STL 405

Pine Canyon Expansion

Request for Planned Residential Development and Modifications
to Engineering Standards

City Council | October 7, 2025

Modification #1: Typical Urban Cul-de-Sac - Modified Back of Curb Radii (Detail No. 10-04-010)

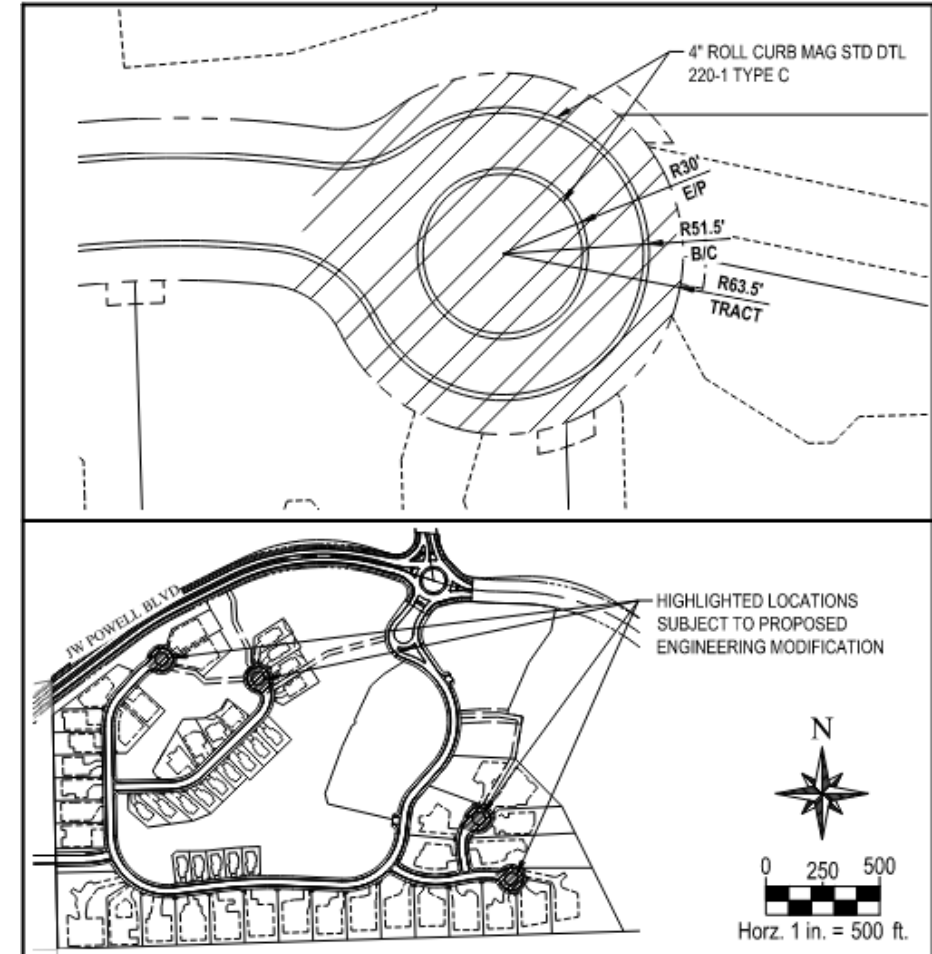
The modification requests a reduction to the back of curb radii and adding a circular landscape island in the cul-de-sac. The City Engineer has recommended approval of this request with the following conditions:

1. Cul-de-sac shall be signed for no parking
2. Cul-de-sac curb shall be painted red indicating a fire lane and no parking
3. A concrete pad of sufficient length and width for 2 solid waste carts shall be provided behind the back of the cul-de-sac curb for each parcel prior to a certificate of occupancy

Modification #2: Residential Local “Wide” Street Section - Modify to Eliminate Sidewalks (Detail No. 10-09-037).

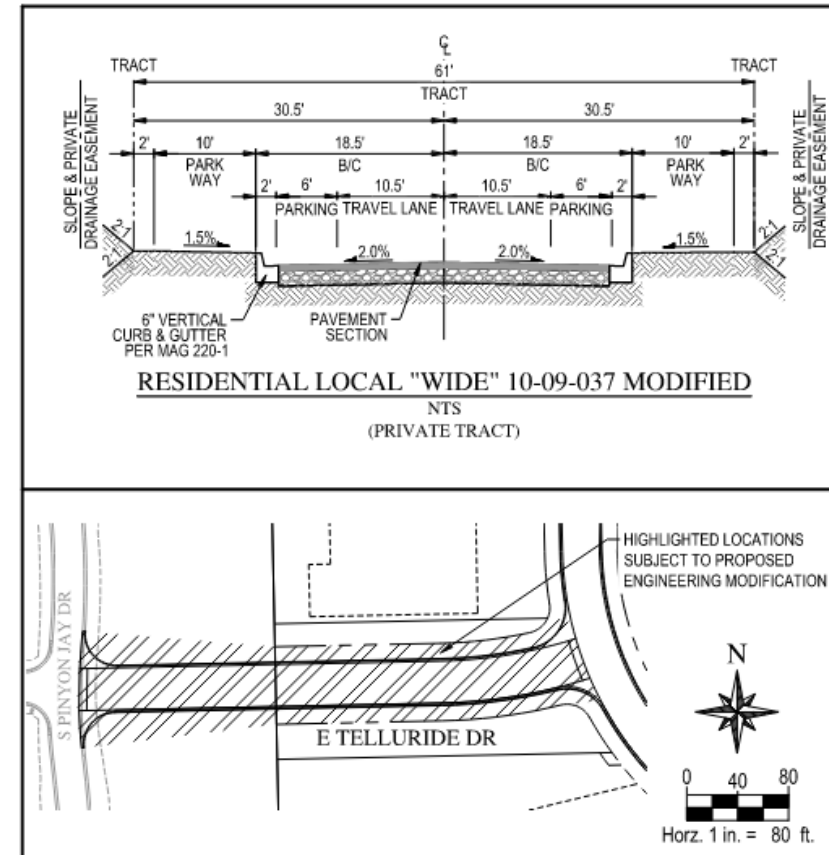
The modification requests the elimination of sidewalks from the Residential Local Wide Street Section. The City Engineer has recommended approval of this request with the following conditions:

1. Street segment shall be signed for no parking
2. Curb along the affected street segment shall be painted red indicating a fire lane and no parking.

Modification #3: Residential Local Street Section - Modify to Eliminate Sidewalks (Detail No. 13-10-09-038).

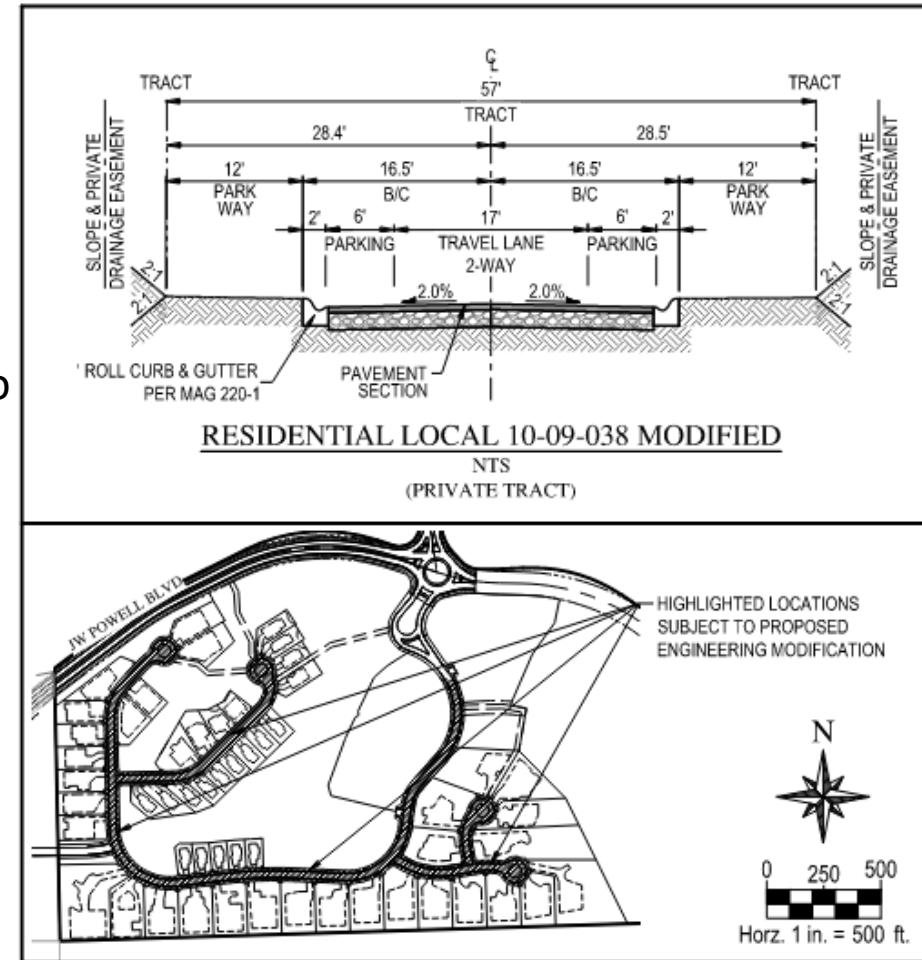
The modification requests the elimination of sidewalks from the Residential Local Street Section. The City Engineer has recommended approval of this request with the following conditions:

1. The final plat shall specify the type of roll curb & gutter (Type C or Type D) to be utilized as part of the local roadway cross section detail

Modification #4: Entry Road - Modification to Street Section (Detail No. 10-09-038).

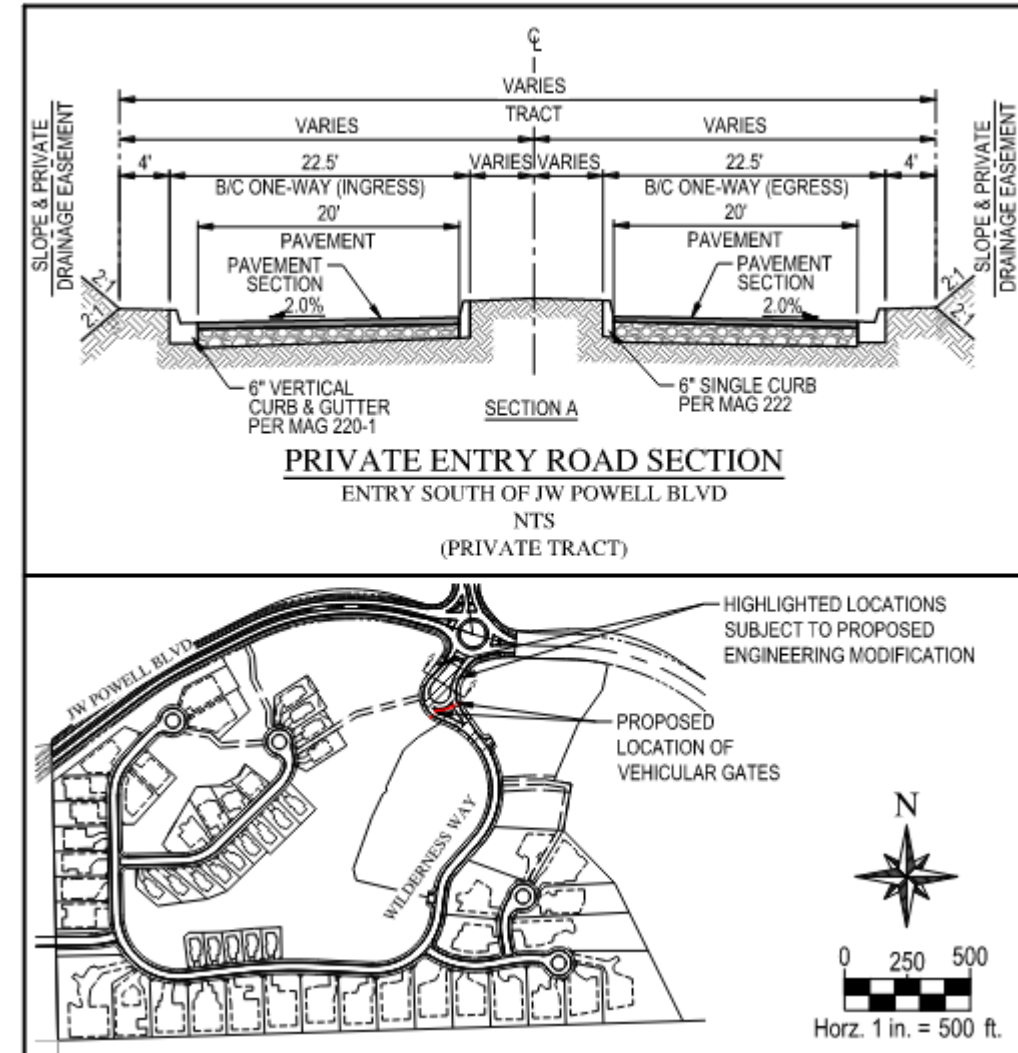
The modification requests to utilize an Entry Road Section extending a short distance to/from JW Powell Boulevard, consisting of a boulevard-type entry with two (2) 20 FT driveways separated by a raised median tract. The City Engineer has recommended approval of this request with the following conditions:

1. Entry and exit lanes shall be signed for no parking
2. Entry and exit lanes shall be painted red, indicating a fire lane and no parking
